RE: 1-7 HARGRAVE PLACE (REF: 2022/0425/P) - DAYLIGHT & SUNLIGHT

I write in response to the planning objection submitted by Margaret Conroy in relation to the proposed development at 1-7 Hargrave Place. Waldrams provided a daylight and sunlight report (dated 18th January 2022) which assessed the impact of the proposed development following the methodology provided in the BRE Guidelines.

Image 1: Floorplan of 7 Brecon Mews (north/north-east approximately towards the top of the page i.e. 1-7 Hargrave Place)

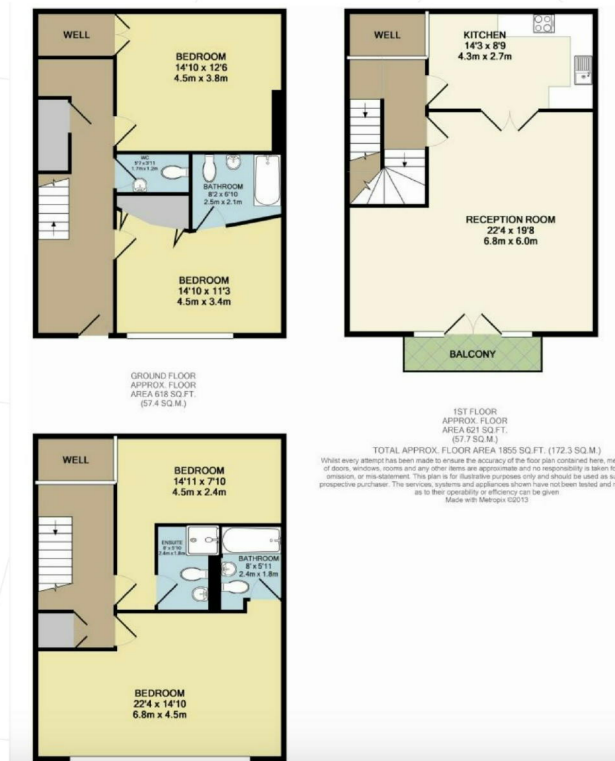
"No consideration has been given by the applicant to the detrimental impact of this extension on the closely neighbouring houses on Brecon Mews; said houses all have roof lights and lightwells at the rear to provide light and ventilation to the rooms at the back. The extra storey on Hargrave Place will block the daylight and sunlight to Brecon Mews..."

As noted by the objector, the only windows in the northern elevation of 5 to 7 Brecon Mews are rooflights that are positioned either nearly horizontally or at an angle of around 45° to the vertical. This is confirmed by the floorplan of 7 Brecon Mews obtained from local estate agent listings which shows no windows in the northern elevation (see image 1 on the following page). Given their orientation, these rooflights enjoy a far larger sky view than a standard vertically orientated window.

The BRE Guidelines recommend that the level of daylight received by windows is measured in terms of Vertical Sky Component (VSC) which is directly linked to the sky view available to a particular window. In our professional opinion, given the relatively small size of the proposed development and the large amount of sky view enjoyed by these rooflights, any potential daylight impact to these windows is likely to be very small and unnoticeable. All rooflights in 5-7 Brecon Mews are likely to retain well in excess of the 27% VSC daylight target value referred to in the BRE Guidelines with the proposal in place and so will remain well daylighted. These windows were not included within our daylight and sunlight report for this reason.

In sunlight terms, the proposed development is located almost directly north of 5-7 Brecon Mews. In the United Kingdom, the sun moves across the southern sky and so no material sunlight impact can be caused by the proposed development to Brecon Mews.
